CITY OF PORTLAND
DRAFT Facility Report
Fire and Rescue

INTERNAL REVIEW DRAFT

F&R-12: STATION 12 - SANDY BLVD
8645 NE SANDY BLVD., PORTLAND OR

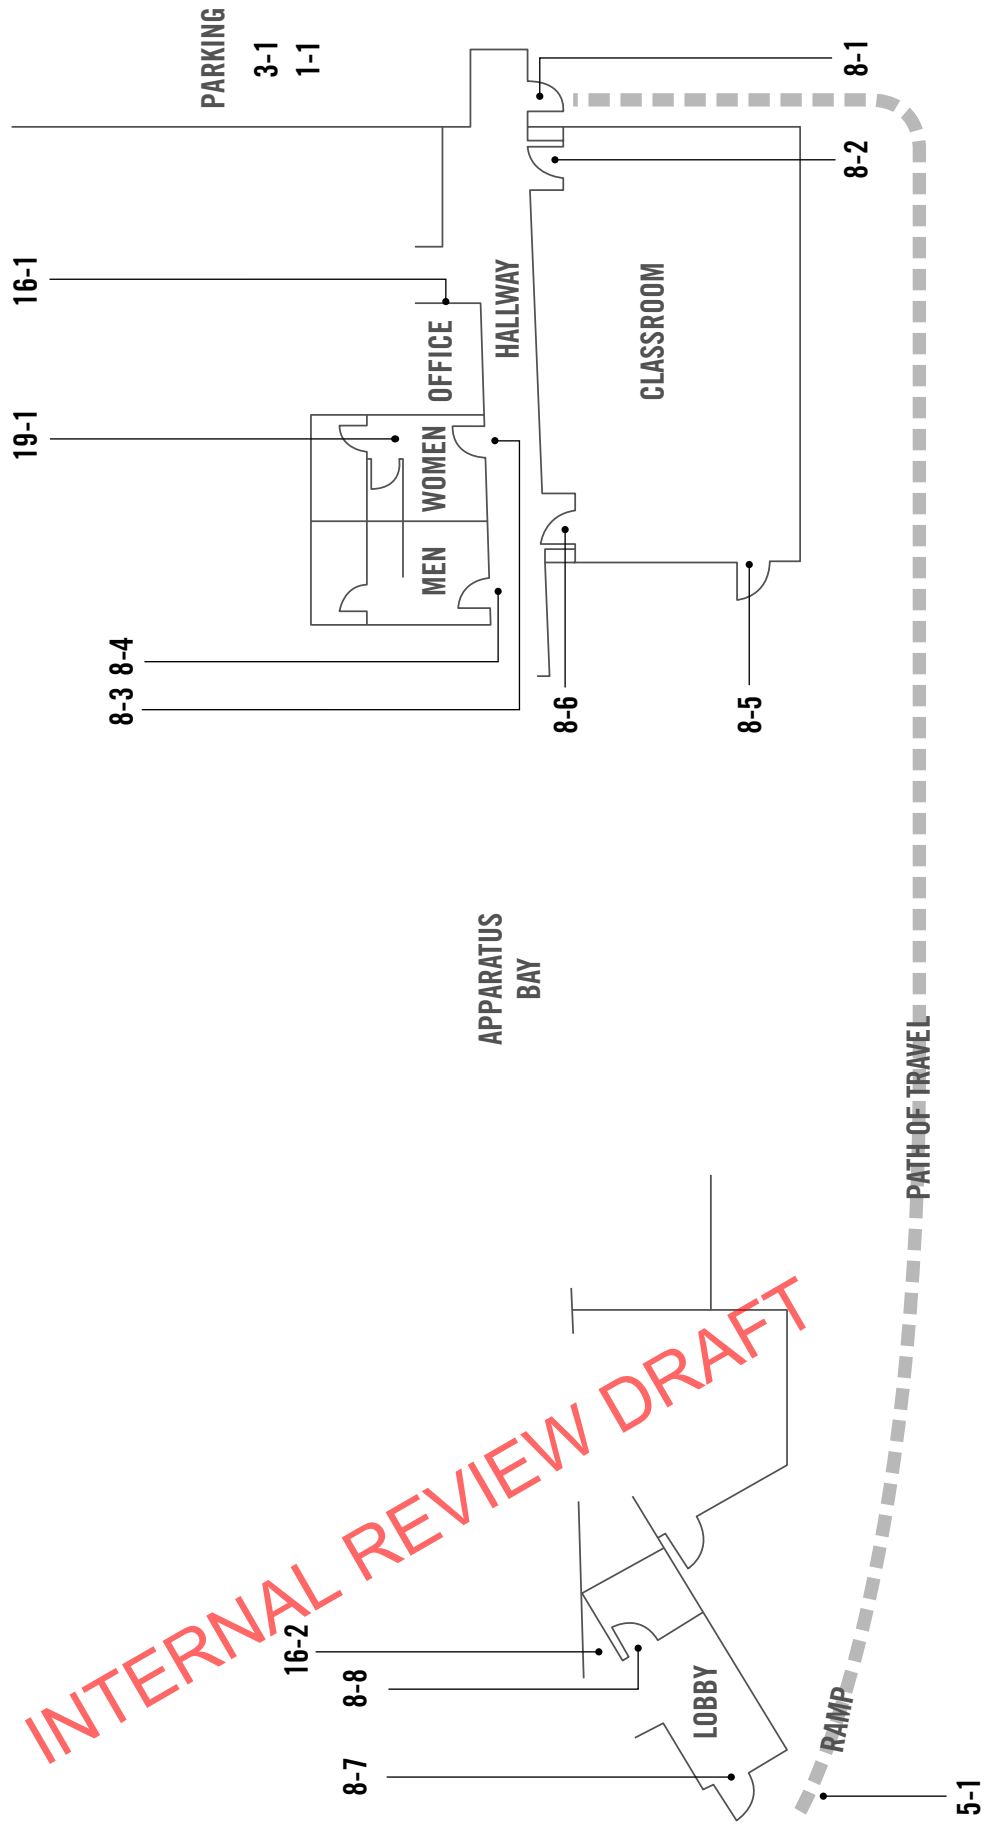
Exterior		
1 - 1	Parking Area	Priority:
Install sign		\$250
Notes: White on blue ISA sign. Required: No 'Reserved Parking' sign on white retroreflective background, with green retroreflective legend, and a white ISA symbol on blue retroreflective symbol.		
State: 1106.7.2		
Federal: 502.6, 703.7.2.1		
Install van parking sign		\$250
Notes: A separate Van Accessible sign is not provided.		
State: 1106.5		
Federal: 208.2.4, 502.6		
Regrade surface		\$5,202
Notes: Slope of parking and access aisle 2.3% to 2.5% (2% max.)		
State: ---		
Federal: 502.4, 504.4		
3 - 1	Curb Ramp	Priority:
Install, replace or modify curb ramp		\$2,460
Notes: Slope of curb ramp is 8.7% (8.33% max.) Cross slope is 2.5% (2% max.)		
State: ---		
Federal: 405.2, 405.3, 406.1		
Provide level landing		\$153
Notes: Level landing provided at the top of the curb ramp is 2.2% (2% max.)		
State: ---		
Federal: 406.4, 406.7		
5 - 1	Ramp	Priority:
Provide level landing		\$340

Notes: Bottom landing slope ranges from 4.2-4.6% (2% max.)		
State: ---		
Federal: 302, 405.7.1

Floor 1		
8 - 1	Door/Gate	Priority:
Provide sign(s) indicating accessible entries and facilities		\$250
Notes: Primary entrance does not have International Symbol of Accessibility.		
State: ---		
Federal: 216.6		
Adjust door closer		\$75
Notes: Exterior door operating effort is 12.5 lbs. (8.5 lbs. max.).		
State: 1101.2.2.5		
Federal: 404.2.9		
Provide additional strike edge clearance		\$3,000
Notes: Strike edge clearance on the pull side of the door is 15" (18" min.)		
State: ---		
Federal: 404.2.4.1		
Install or modify permanent room signs		\$125
Notes: Tactile and Braille EXIT sign is not provided.		
State: ---		
Federal: 703.4.1		
8 - 2	Door/Gate	Priority:
Modify door window or side light		\$500
Notes: Window in door is located at 53-3/4" AFF (43" max.)		
State: ---		
Federal: 404.2.11		
Provide additional strike edge clearance		\$3,000
Notes: Strike edge clearance on the pull side of the door is 16-3/4" (18" min.)

State: ---		
Federal: 404.2.4.1		
Install or modify permanent room signs		\$125
Notes: Tactile and Braille EXIT sign is not provided.		
State: ---		
Federal: 703.4.1		
8 - 3	Door/Gate	Priority:
Adjust door closer		\$75
Notes: Operating effort for the women's restroom door is 14 lbs (5 lbs max.)		
State: 1101.2.2.5		
Federal: 404.2.9

Floor 1		
8 - 4	Door/Gate	Priority:
Adjust door closer		\$75
Notes: Operating effort for the men's restroom door is 13 lbs (5 lbs max.)		
State: 1101.2.2.5		
Federal: 404.2.9		
8 - 5	Door/Gate	Priority:
Adjust door closer		\$75
Notes: Exterior door operating effort is 13 lbs. (8.5 lbs max.)		
State: 1101.2.2.5		
Federal: 404.2.9		
Install or modify permanent room signs		\$125
Notes: Tactile and Braille EXIT sign is not provided.		
State: ---		
Federal: 703.4.1		
8 - 6	Door/Gate	Priority:
Modify door window or side light		\$500
Notes: Window in door is located at 54-3/4" AFF (43" max.)		
State: ---		
Federal: 404.2.11		
8 - 7	Door/Gate	Priority:
Provide sign(s) indicating accessible entries and facilities		\$250
Notes: Primary accessible entrance is not marked by the International Symbol of Accessibility.		
State: ---		
Federal: 216.6		
Adjust door closer		\$75
Notes: Exterior door operating effort is 12 lbs (8.5 lbs max.) Sweep time is 2 seconds (5 seconds min.)

State: ---, 1101.2.2.5		
Federal: 404.2.8.1, 404.2.9		
Regrade surface		\$340
Notes: Slope ranges from 4.2-4.6% on the swing side of the door. (2% max.)		
State: ---		
Federal: 404.2.4.4

Floor 1		
8 - 8	Door/Gate	Priority:
Adjust door closer		\$75
Notes: Operating effort is 17 lbs (5 lbs max.)		
State: 1101.2.2.5		
Federal: 404.2.9		
16 - 1	Built-in Elements	Priority:
Provide an accessible counter		\$2,500
Notes: Counter height is 39-1/4" (36" max.)		
State: ---		
Federal: 904.4		
16 - 2	Built-in Elements	Priority:
Provide an accessible counter		\$2,500
Notes: Counter height is 42" (36" max.)		
State: ---		
Federal: 904.4		
19 - 1	Multiple User Restroom	Priority:
Modify lavatory or counter clearances		\$0
Notes: Knee space and toe clearance are not provided due to removable metal rod under the lavatory of the women's restroom.		
State: ---		
Federal: 306.2, 306.2.3, 306.3, 306.3.3		
Provide or replace compartment door hardware		\$250
Notes: U-shaped handles are not provided on the front and back of the compartment door. Strike edge clearance on the pull side of the door is 8-1/2" (18" min.)		
State: ---

F&R-16: STATION 16 - SYLVAN
1715 SW SKYLINE BLVD., PORTLAND OR

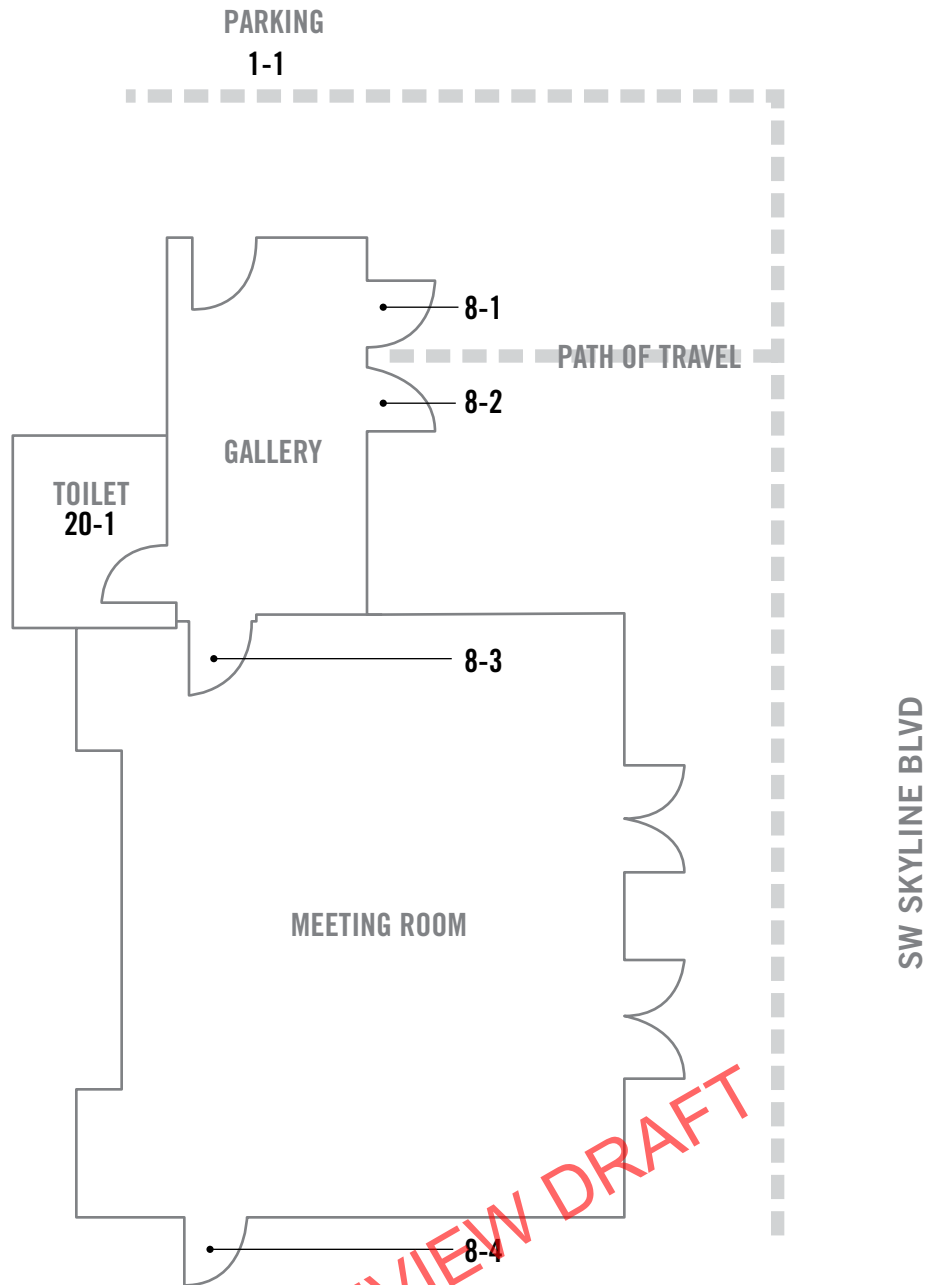
Exterior		Priority:
1 - 1	Parking Area	Priority:
Provide or modify accessible spaces		\$85
Notes: Pavement ISA stencil with 2-1/4" to 4" stroke (3" min.)		
State: 1106.6, 1106.7.1, 1106.7.2		
Federal: ---, 502.2, 502.6		
Install van parking sign		\$250
Notes: No van accessible sign provided. Required when only one accessible parking space is required.		
State: 1106.5		
Federal: 208.2.4, 502.6		
Regrade surface		\$1,836
Notes: Access aisle slope is 2.2% (2% max.)		
State: ---		
Federal: 502.4, 504.4		
Install sign		\$250
Notes: Sign is white ISA on blue background. Required: "Reserved Parking" sign on a white retroreflective background 12" wide by 18" high, with a green retroreflective legend, and a white ISA symbol on blue retroreflective symbol.		
State: 1106.7.2		
Federal: 502.6, 703.7.2.1

Floor 1		
8 - 1	Door/Gate	Priority:
Provide sign(s) indicating accessible entries and facilities		\$250
Notes: Primary entrance is not identified with International Symbol of Accessibility.		
State: ---		
Federal: 216.6		
Install or modify permanent room signs		\$125
Notes: The door has no tactile and Braille EXIT sign.		
State: ---		
Federal: 703.4.1		
Adjust door closer		\$75
Notes: Exterior door operating effort is 20 lbs. (8.5 lbs. max.).		
State: 1101.2.2.5		
Federal: 404.2.9		
8 - 2	Door/Gate	Priority:
Provide sign(s) indicating accessible entries and facilities		\$250
Notes: Primary entrance is not identified with International Symbol of Accessibility.		
State: ---		
Federal: 216.6		
Install or modify permanent room signs		\$125
Notes: The door has no tactile and Braille EXIT sign.		
State: ---		
Federal: 703.4.1		
Adjust door closer		\$75
Notes: Exterior door operating effort is 20 lbs. (8.5 lbs. max.).

State: 1101.2.2.5		
Federal: 404.2.9		
8 - 3	Door/Gate	Priority:
Install or modify permanent room signs		\$125
Notes: The door has no tactile and Braille EXIT sign.		
State: ---		
Federal: 703.4.1

Floor 1		
8 - 4	Door/Gate	Priority:
Install or modify permanent room signs		\$125
Notes: The door has no tactile and Braille EXIT sign.		
State: ---		
Federal: 703.4.1		
Adjust door closer		\$75
Notes: Exterior operating effort is 11 lbs. (8.5 lbs. max.).		
State: 1101.2.2.5		
Federal: 404.2.9		
20 - 1	Single User Restroom	Priority:
Replace or reposition fixtures		\$1,500
Notes: Centerline of water closet is 19-3/4" (16-18" req.).		
State: ---		
Federal: 604.2		
Replace toilet or adjust toilet seat height		\$1,000
Notes: Toilet seat height 19-1/2" (17-19" req.).		
State: ---		
Federal: 604.4		
Modify lavatory or counter clearances		\$2,500
Notes: Knee space is 26-1/2" (27" min.) when measured 8" deep at centerline of lavatory.		
State: ---		
Federal: 306.3, 306.3.3

F&R-17: STATION 18 - MULTNOMAH VILLAGE
8720 SW 30TH AVE., PORTLAND OR

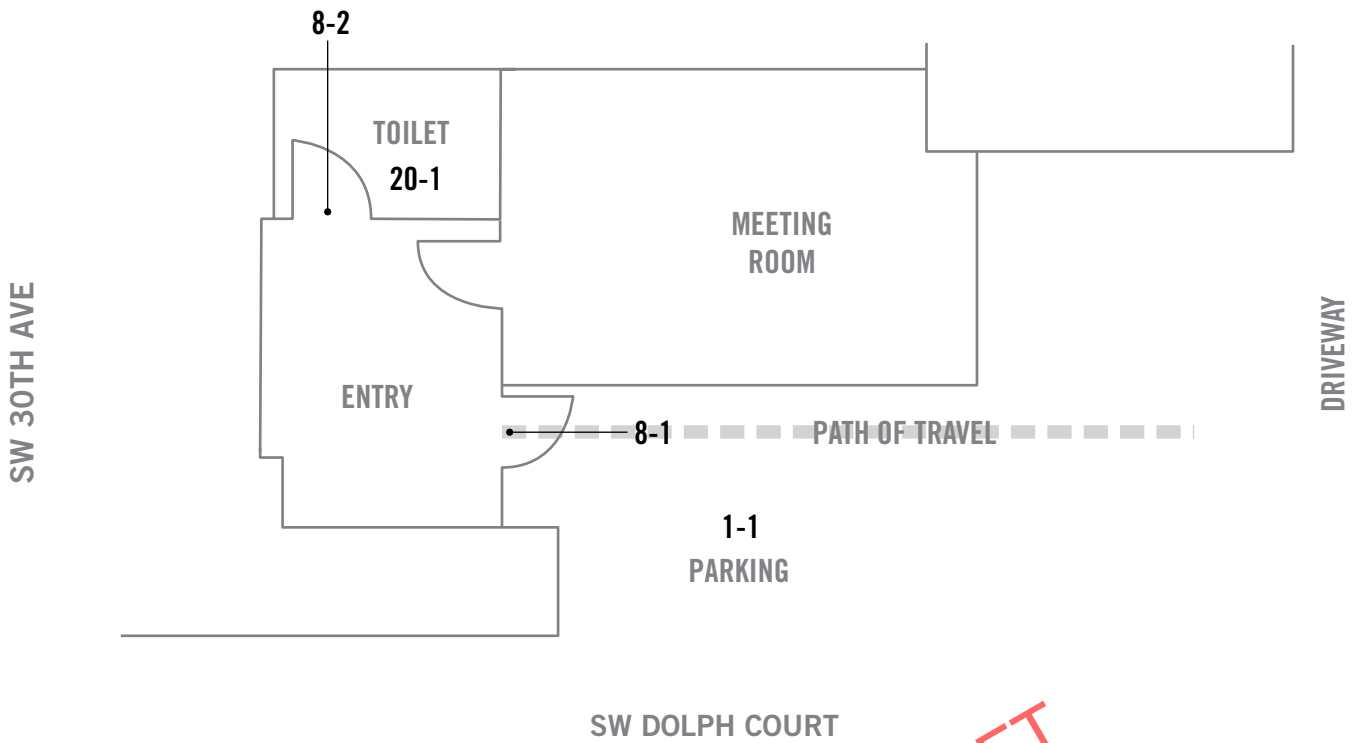
Exterior		
1 - 1	Parking Area	Priority:
Provide or modify accessible spaces		\$85
Notes: International Symbol of Accessibility stencil is not provided. Accessible parking space is not striped.		
State: 1106.6, 1106.7.2		
Federal: ---, 502.6		
Provide or modify accessible access aisles		\$210
Notes: Access aisle is provided, but not striped.		
State: 1106.7.2		
Federal: 502.3.3		
Regrade surface		\$5,202
Notes: Slope of parking spaces and access aisles range from 3.1-4.2% (2% max.)		
State: ---		
Federal: 502.4, 504.4		
Install sign		\$250
Notes: Signs are mounted 30-36" above the parking space (60" min.)		
State: 1106.7.2		
Federal: 502.6		
Install van parking sign		\$250
Notes: Van Accessible sign is 12"x6" (18"x9" min.) The lettering for the word VAN is 1-1/2" high (2" min.) and the word ACCESSIBLE is 1" high (1-1/2" min.)		
State: 1106.5		
Federal: 208.2.4, 502.6

Floor 1		
8 - 1	Door/Gate	Priority:
	Provide sign(s) indicating accessible entries and facilities	\$250
Notes: Primary accessible entrance is not marked with the International Symbol of Accessibility.		
State: ---		
Federal: 216.6		
	Install or modify permanent room signs	\$125
Notes: Braille EXIT sign is not provided.		
State: ---		
Federal: 703.4.1		
	Adjust door closer	\$75
Notes: Exterior door operating effort is 10 lbs (8.5 lbs max.)		
State: 1101.2.2.5		
Federal: 404.2.9		
8 - 2	Door/Gate	Priority:
	Provide additional strike edge clearance	\$3,000
Notes: Grab bars obstruct the strike edge clearance on the pull side of the door.		
State: ---		
Federal: 404.2.4.1		
	Adjust door closer	\$75
Notes: Operating effort is 11 lbs (5lbs max.)		
State: 1101.2.2.5		
Federal: 404.2.9

Floor 1	
20 - 1	Single User Restroom
Priority:	
Replace or reposition fixtures	\$1,500
Notes: Centerline of the water closet from the wall is 21-1/2" (16-18" req.)	
State: ---	
Federal: 604.2	
Replace or reposition dispensers or mirrors	\$300
Notes: Reflecting surface of mirror is mounted at 43" AFF (40" max.) Paper towel dispenser is mounted at 57" AFF (48" max.)	
State: ---	
Federal: 603.3	
Modify lavatory or counter clearances	\$2,500
Notes: Centerline of the lavatory from the wall is 11-1/2" (15" min.)	
State: ---	
Federal: 606.2	
Insulate water lines	\$250
Notes: Hot water pipes are not insulated.	
State: ---	
Federal: 606.5	
Install sign	\$250
Notes: Restroom signage is mounted 68" AFF (60" req.)	
State: ---	
Federal: 703, 703.4.1, 703.4.2

F&R-31: BELMONT LEARNING CENTER
900 SE 35TH AVE., PORTLAND OR

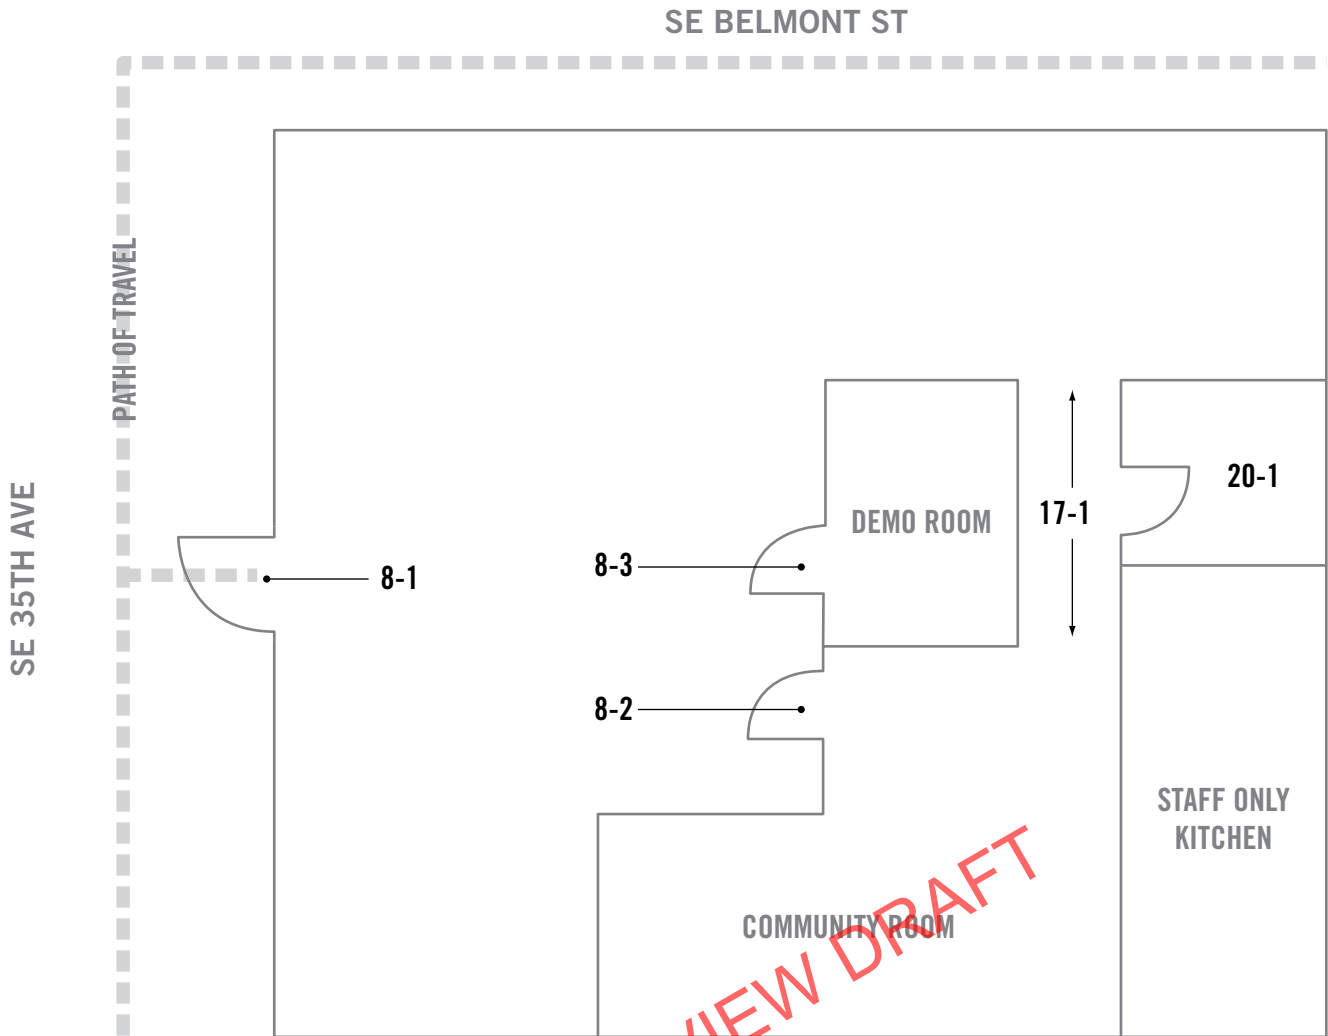
Floor 1		
8 - 1	Door/Gate	Priority:
Provide sign(s) indicating accessible entries and facilities		\$250
Notes: Primary accessible entrance is not marked with the International Symbol of Accessibility.		
State: ---		
Federal: 216.6		
Adjust door closer		\$75
Notes: Exterior door operating effort is 12 lbs (8.5 lbs max.)		
State: 1101.2.2.5		
Federal: 404.2.9		
Replace or modify door threshold		\$500
Notes: Door threshold is patched with asphalt. Slope in threshold area is 8.3% (2% max.)		
State: ---		
Federal: 404.2.5		
Install or modify permanent room signs		\$125
Notes: Tactile and Braille EXIT sign is not provided.		
State: ---		
Federal: 703.4.1

Floor 1		
8 - 2	Door/Gate	Priority:
	Enlarge door opening	\$1,650
Notes: Clear width of opening is 29-1/2" (32" min.)		
State: ---		
Federal: 404.2.3		
	Modify door window or side light	\$500
Notes: Window in door is located 48-1/2" AFF (43" max.)		
State: ---		
Federal: 404.2.11		
	Replace or adjust door hardware	\$1,000
Notes: Door hardware is a knob that requires grasping and twisting.		
State: ---		
Federal: 309.4		
	Provide or modify door kickplate	\$100
Notes: There is a door stop mounted in the kick plate.		
State: ---		
Federal: 404.2.10		
	Provide additional strike edge clearance	\$3,000
Notes: Strike edge clearance on the pull side of the door is 4-1/2" (18" min.). Strike edge clearance on the push side of the door is 3-1/2" (12" min.)		
State: ---		
Federal: 404.2.4.1		
8 - 3	Door/Gate	Priority:
	Enlarge door opening	\$1,650
Notes: Clear width of opening is 29-1/2" (32" min.)		
State: ---		
Federal: 404.2.3

Replace or adjust door hardware	\$1,000
Notes: Door hardware is a knob that requires grasping and twisting.		
State: ---		
Federal: 309.4		
	Provide or modify door kickplate	\$100
Notes: Door stop is mounted in the kick plate.		
State: ---		
Federal: 404.2.10

Floor 1		
17 - 1	Corridor / Aisle	Priority:
Widen corridor		\$5,000
Notes: Corridor width narrows to 28-1/4" (36" min.) Approx. 6 ft.		
State: ---		
Federal: 403.5.1		
20 - 1	Single User Restroom	Priority:
Renovate restroom		\$75,000
Notes: This single user restroom is not accessible and will require a complete renovation.		
State: ---		
Federal: 604.8.1.2

F&R-36: FIRE MARSHAL'S OFFICE
1280 SE GIDEON PORTLAND OR

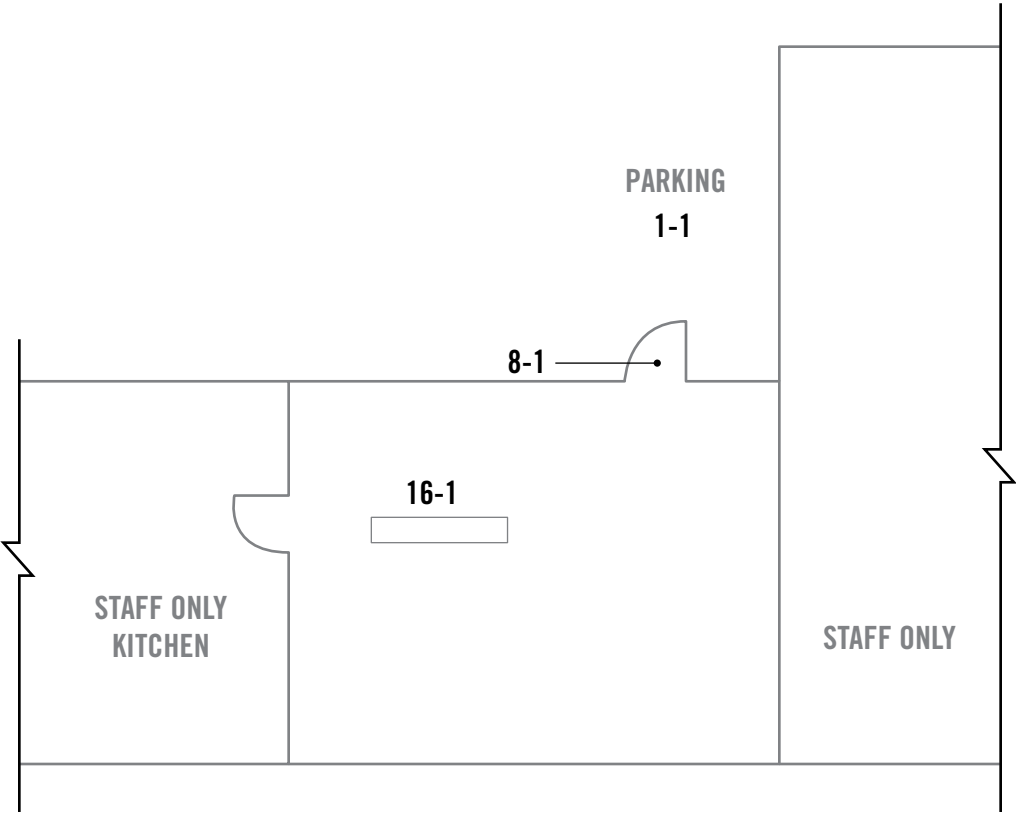
Exterior		Priority:
1 - 1	Parking Area	Priority:
Provide or modify accessible access aisles		\$210
Notes: Access aisle is not provided.		
State: 1106.7.2		
Federal: 502.3.3		
Provide or modify accessible spaces		\$85
Notes: Pavement stencil too faded to measure. Required: 28" high by a min. 24" wide ISA, painted with a min. 3" stroke width of retroreflective white paint on an optional blue retroreflective background.		
State: 1106.7.2		
Federal: 502.6		
Install sign		\$250
Notes: Sign is white ISA on blue background. Req.: "Reserved <input type="checkbox"/> Parking" sign on a white retroreflective background 12" <input type="checkbox"/> wide by 18" high, with a green retroreflective legend, and a <input type="checkbox"/> white ISA symbol on blue retroreflective symbol. Sign is mounted 58-3/4" (60" min.)		
State: 1106.7.2		
Federal: 502.6, 703.7.2.1

Floor 1		
8 - 1	Door/Gate	Priority:
	Provide sign(s) indicating accessible entries and facilities	\$250
Notes: Primary accessible entrance is not marked with the International Symbol of Accessibility.		
State: ---		
Federal: 216.6		
	Replace or modify door threshold	\$125
Notes: Threshold is 1/2" (1/4" max.)		
State: ---		
Federal: 404.2.5		
16 - 1	Built-in Elements	Priority:
	Provide an accessible counter	\$2,500
Notes: Counter height is 41-3/4" (36" max.)		
State: ---		
Federal: 904.4
